Access Compliance Report Public Rights-of-Way (Curb Ramps)

Main Street: CERRITOS_AVE		Cross Street: GILBERT_ST		Location:	NW
ADA ID: RPAT211122121443	Ramp Type: Type 4 - Parallel	Initial Pass/Fail: Fail	Overall Compliance: No	Severity Score:	2
Codes/Mitigation Info/Possible Solution			Field Measurements/Component Compliance

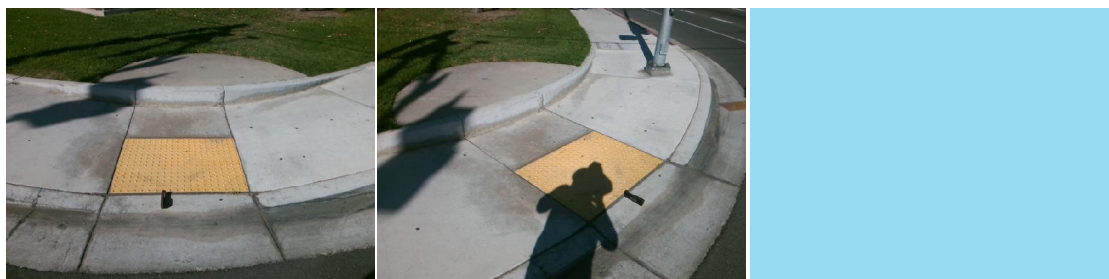
Compliance	Description	Data	Compliance	Description	Data
N/A	Ramp Length LT (in)	79	N/A	Ramp Length RT (in)	72
Yes	Ramp Width LT (in)	71	Yes	Ramp Width RT (in)	72
Yes	Ramp Run Slope LT (%)	7.3	Yes	Ramp Run Slope RT (%)	7.4
No	Ramp Cross Slope LT (%)	2.3	Yes	Ramp Cross Slope RT (%)	0.8
N/A	Landing Present	N/A	N/A	DWS Provided	N/A
N/A	Landing Length (in)	N/A	N/A	DWS Contrast	N/A
N/A	Landing Width (in)	N/A	N/A	DWS Length (in)	N/A
N/A	Landing Run Slope (%)	N/A	N/A	DWS Full Width	N/A
N/A	Landing Cross Slope (%)	N/A		DWS Offset Type	N/A
N/A	Landing Movement Obstructed?	N/A	N/A	DWS Offset Left (in)	N/A
	Landing Movement Type	N/A	N/A	DWS Offset Right (in)	N/A
N/A	Landing Shared	N/A			
N/A	Clear Space	Yes			
N/A	Clear Space To Crosswalk (in)	48			
N/A	Marked Crosswalk 1	Yes	N/A	Marked Crosswalk 2	Yes
	Crossing 1 Direction	S		Crossing 2 Direction	E
	Marked Crosswalk 1 Width (in)	150		Marked Crosswalk 2 Width (in)	150

Remove & Replace Curb Ramp With Two New Directional Ramps or Equivalent.

R304.5.3, STD 1115
